COMBINATION EDITION

Wizards Workshop

May 2, 1980
Issue 10-9

1480 SERIES

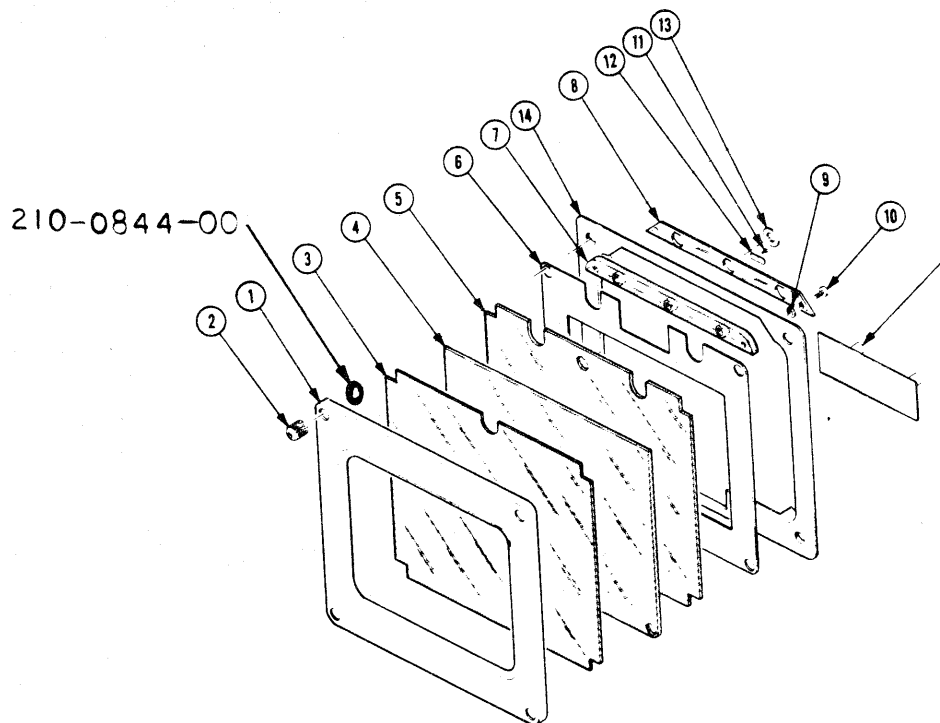
The part number for the rubber washer underneath the CRT Bezel is 210-0844-00. See the following drawing for the location.

Fig. 1

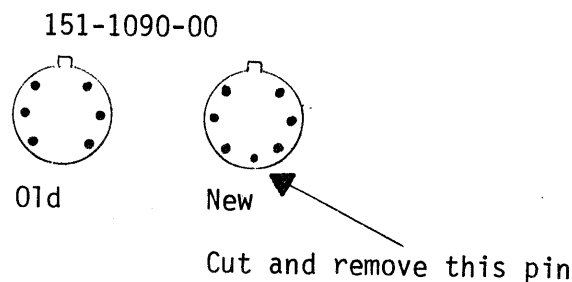
A dual N-Channel Fet, P/N 151-1090-00, used in the CH1 (Q1297) & CH2 (Q1698) vertical input circuit, now has 7 legs instead of 6. (The new leg will have to be removed to fit in the socket, see Fig. 1.) This is due to a change with internal bonding.

The change in bonding effects the capacitance of the FET, which in turn effects the H.F. response of the preamps. To compensate for this change in capacitance R1299, (CH1) and R1798 (CH2) are now selectable with a nominal value of 510Ω , P/N 315-0511-00 and a range of selection from 100Ω to $1K\Omega$. To select the correct value of resistance after replacing Q1297, Q1698:

- 1) Switch the preamp to the 5mv range and input the H.F. square wave. Use 6 div of display.
- 2) Adjust for a flat top within specs.
- 3) Switch to 20mv, and adjust the generator for 6 div.
- 4) If the first 10NS of display is rolled down, select a lower value resistor. If the first 10NS is rolled up, select a higher value resistor.
- 5) Due to interaction, check the 5mv range and readjust as necessary. If an adjustment is made, recheck and adjust the 20mv range. Re-check L.F. compensation.

Figure 1. Front View

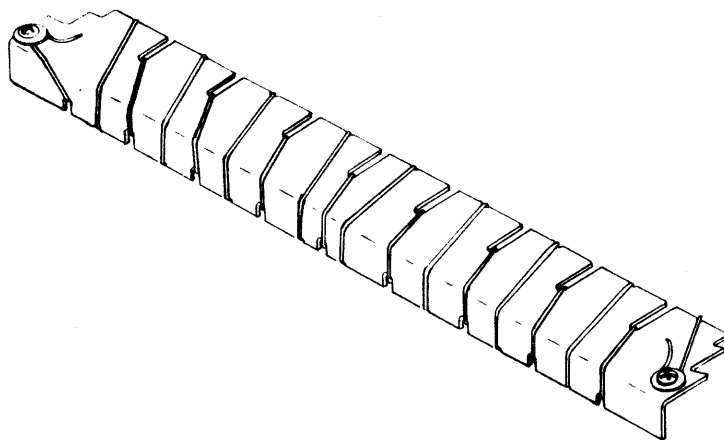
The fishline-wrapped processor entrance guide is not available in assembled form. It must be assembled from two parts: the "frame" and the fishline. The frame is orderable from Tektronix under part number 351-0378-01 (for the 4631 and 4632) or 351-0582-00 (for the 4633A and 4634). The fishline is 25 pound test monofilament line available in a 4 ounce spool under part number 253-0200-00. Assembly is not difficult provided a sample is at hand (see figure 1).

Figure 2. Bottom View

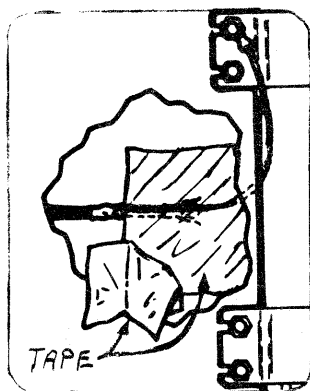
The fishline should be wrapped reasonable taut. If the wrapping is done correctly, a neat symetric pattern is apparent when the assembly is viewed from below (figure 2).

Correct Method

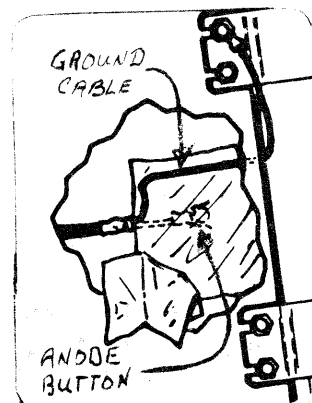
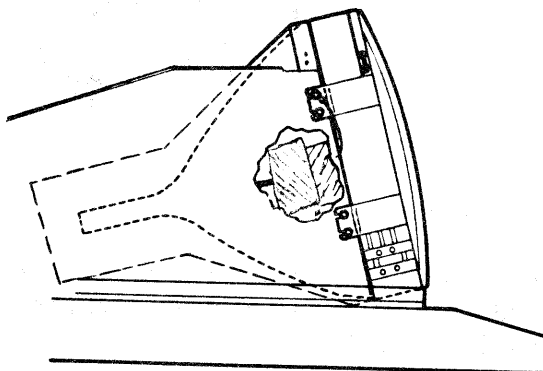
The cause of these multiple failures has been traced to incorrect dressing of the ground cable on the CRT. Below is a illustration showing the location of the cable on one side of the CRT (newer CRTs have a cable on both sides), and two (2) exploded drawings showing the correct and incorrect methods of dressing the cable. What happens is with the cable incorrectly dressed directly over the anode button (target voltage), there is a tendency to short the anode (approx. 250 volts) to the grounding cable.

To remedy this problem the CRT must be removed from the terminal and the CRT Shield Assembly must be removed as per the Service Manual (070-2302-00) on pages 3-4 thru 3-6. With the shield removed notice that there are two (2) pieces of surgical tape holding the wire against the CRT. Be very careful when removing this tape, the silver paint from the anode buttons to the tabs comes off easily. If this paint is removed, the CRT will have to be replaced. As per the illustration, only the top layer of tape needs to be removed. Position the ground wire as shown and cover it back up with the tape. Note that there is an orange wire connecting to another button under these tapes. This is CE-2 and has not been a part of the problem.

(FIGURE 1)

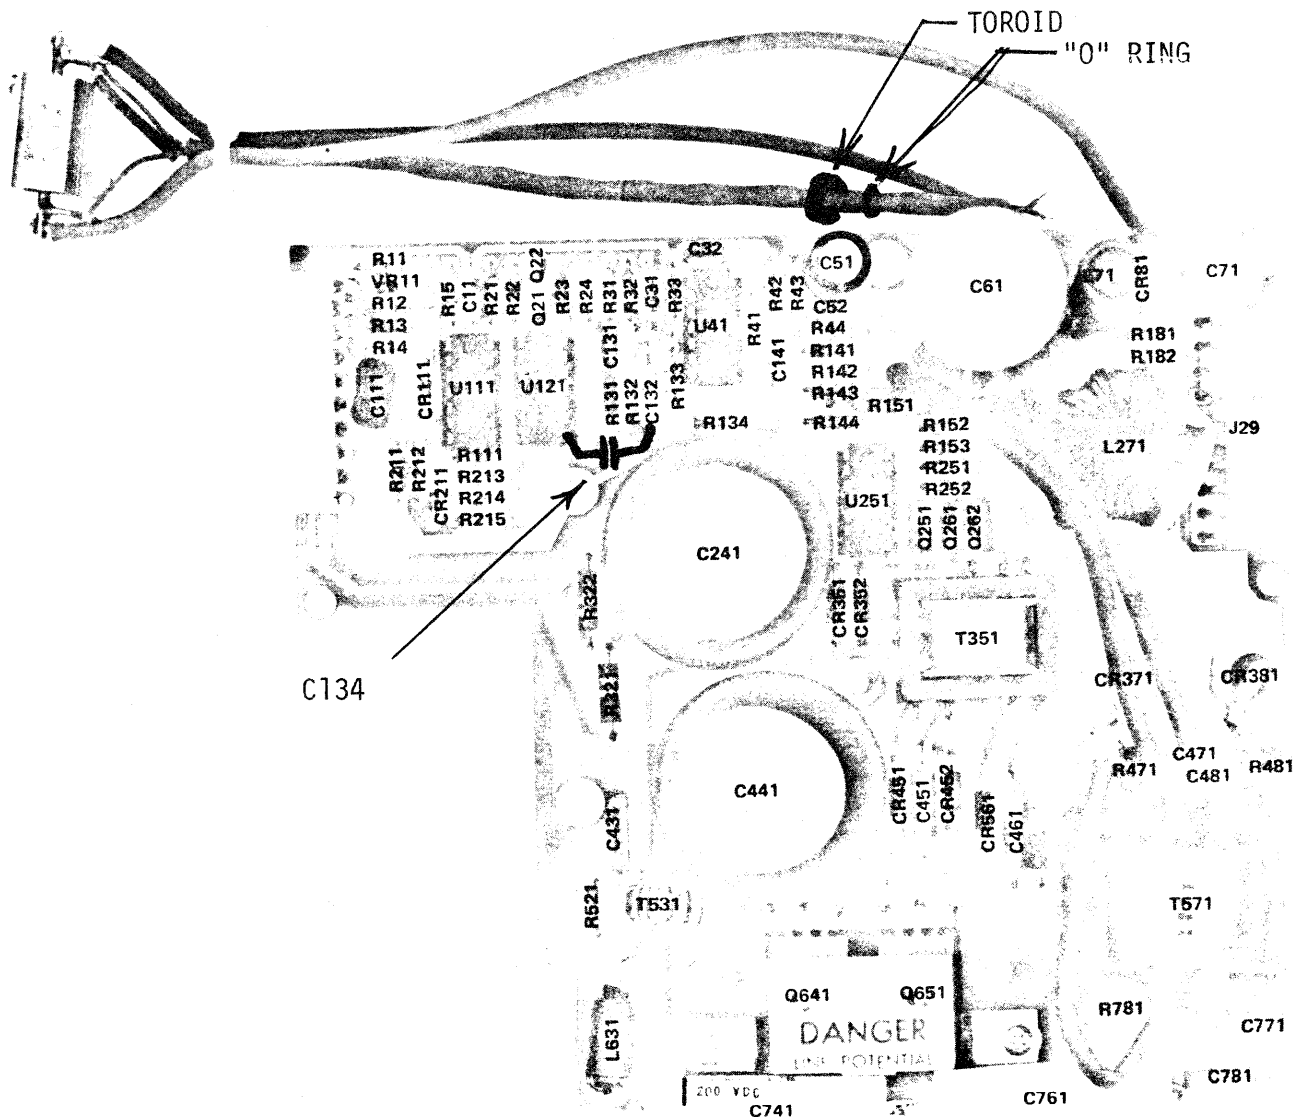
Corporate Mod #39429 adds a capacitor and a toroid to the +5 volt output board. For the 4054 the board level changes from a 670-5622-00 to a 670-5622-01. The board for the 4052 is 672-0833-00. Procedure: (refer to figure 1)

1. Add a 2 μ f CAP C134 P/N 283-0212-00 from the junction of C132, R133, R131 to ground (pin 8 U121)
2. Unsolder the grey cable with the small red and black leads. The red lead attaches to the right side of R134, the black lead attaches to the eyelet under U41. It is important that this be unsoldered at the board, DO NOT UNSOLDER it at the resistor on the back panel.
3. Put the toroid T1003 P/N 276-0640-00 on the gray cable then put an "O" ring 354-0538-00 on the cable to keep the toroid away from the circuit card.
4. Resolder the red and black leads to the circuit card. Red lead to the right side of R134 and the black lead to the eyelet hole under U41.

(FIGURE 2)

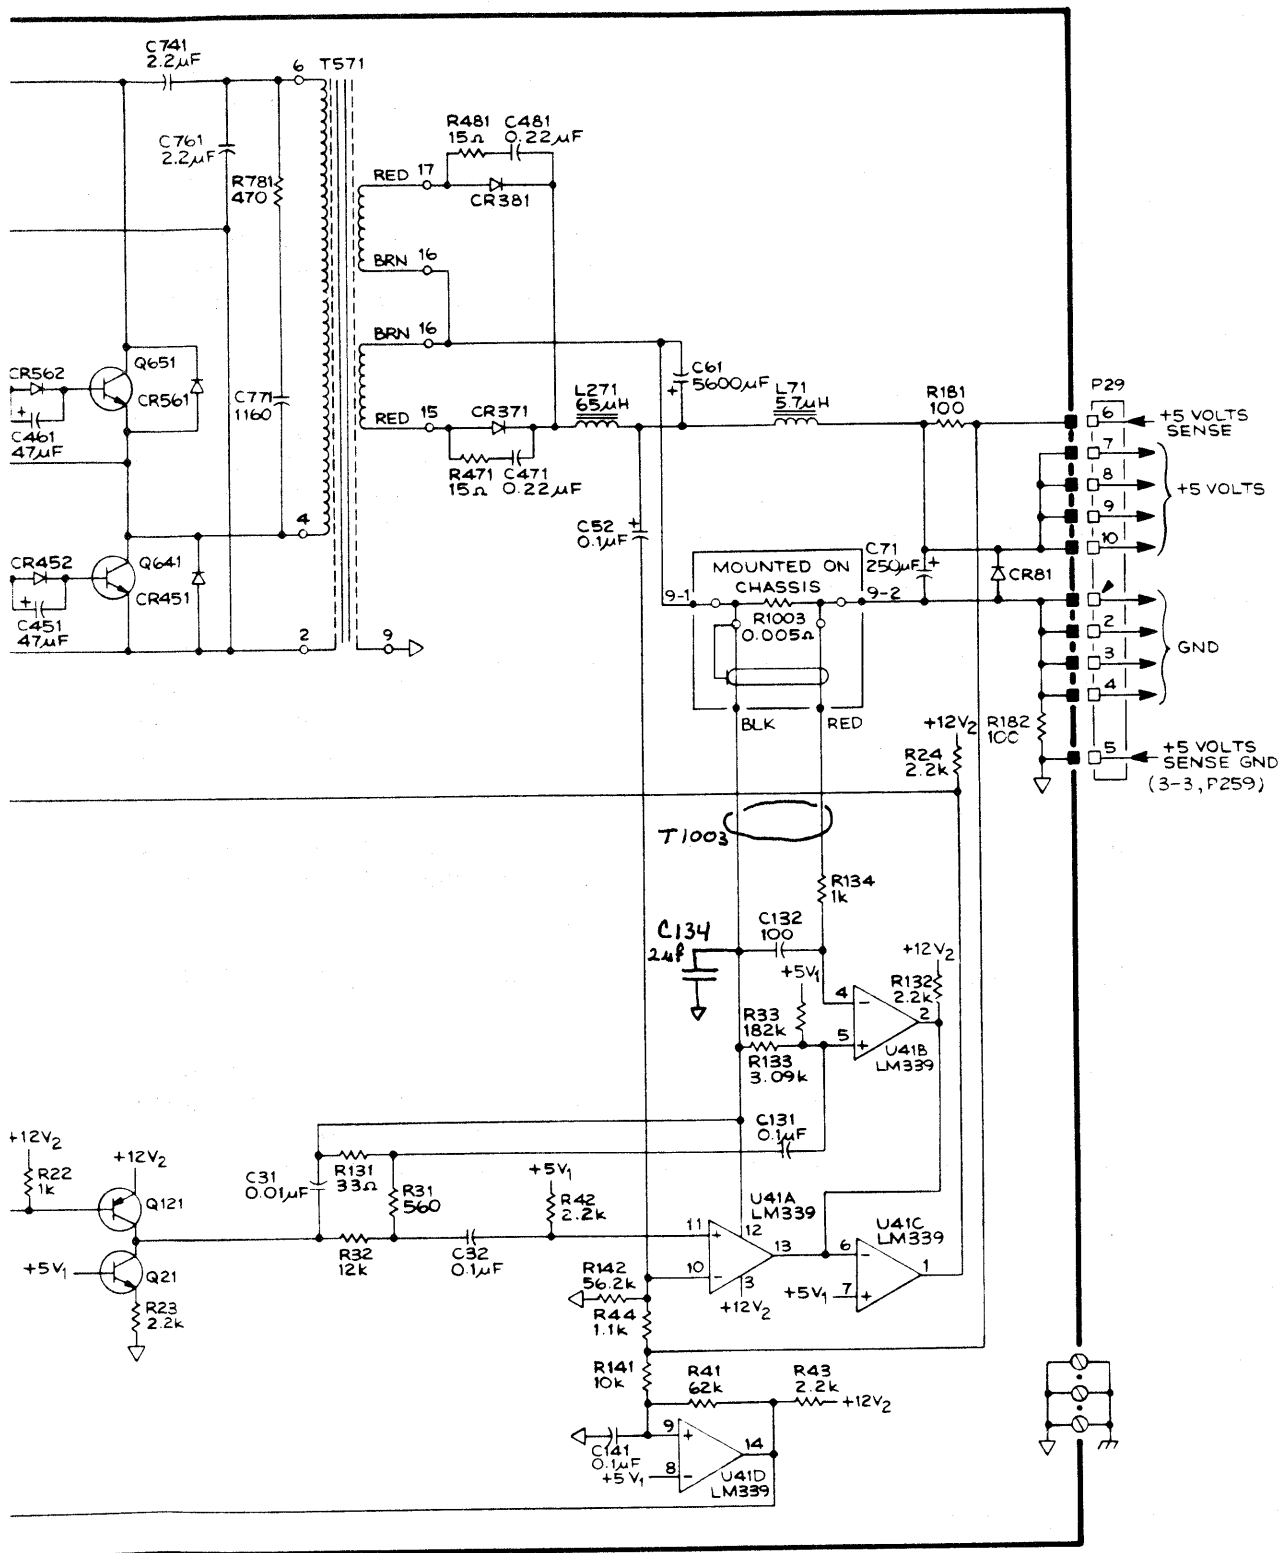
Make the appropriate changes to the schematics and parts lists in the 4052/54 Manuals 070-2829-00 and 070-2839-00 (refer to figure 2).

Figure 1 Schematic 1-1 Power Supply
4052 Service Manual

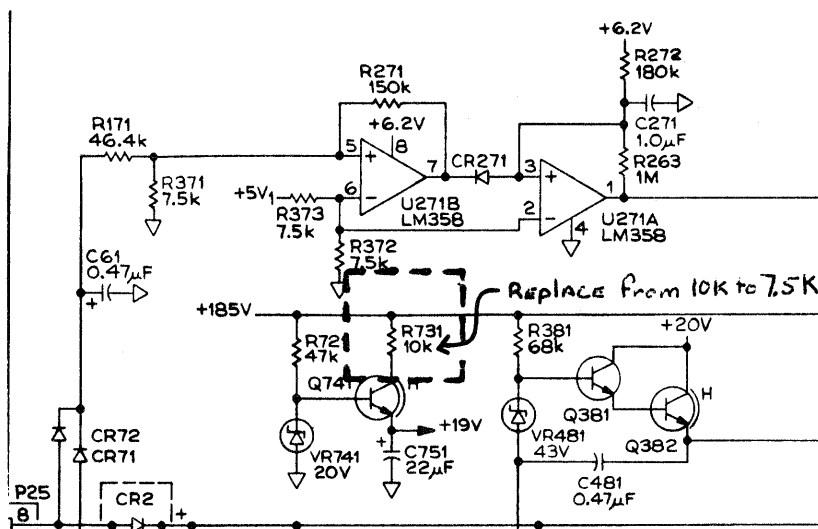
The +15 supply goes out of regulation at low line. The problem is caused by insufficient current capability of the +19V supply used to supply the +15V regulator circuit. This problem could be causing the 4052/54 to randomly lock-up customers units.

The Mod to solve this problem is as follows: (refer to figure 1)

1. Change R731 of the 670-5623-00 regulator board from a 10K (321-0289-03) resistor to a 7.5K. (321-0277-00)

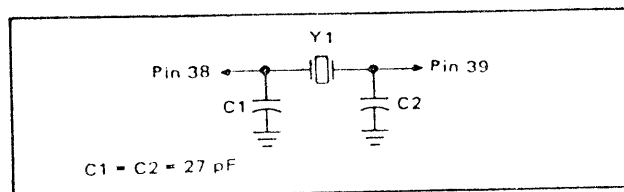
Another problem is the way the clock circuit is implemented on the user's prototype. Motorola specifies that the parallel crystal with associated capacitors be connected as shown below. This circuit configuration is not intended to drive any other circuitry that requires clock frequency used by the microprocessor. This is to say, that due to load capacitance this crystal clock should only drive the user's 6802 microprocessor or our 6802 probe tip only. Often, the user is able to drive other circuitry with a connection to Pin 38 or 39, but it is not recommended. Our probe due to added load capacitance, most likely will not operate if extra circuitry is being driven.

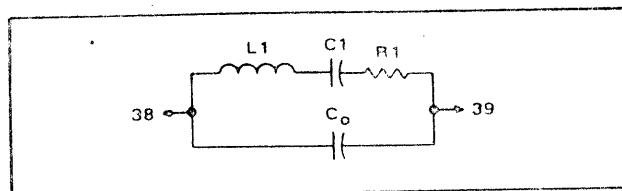
Crystal Specification — The 4.0 MHz specification case is shown below:

The following is the figure and parameters to be supplied to the crystal vendor.
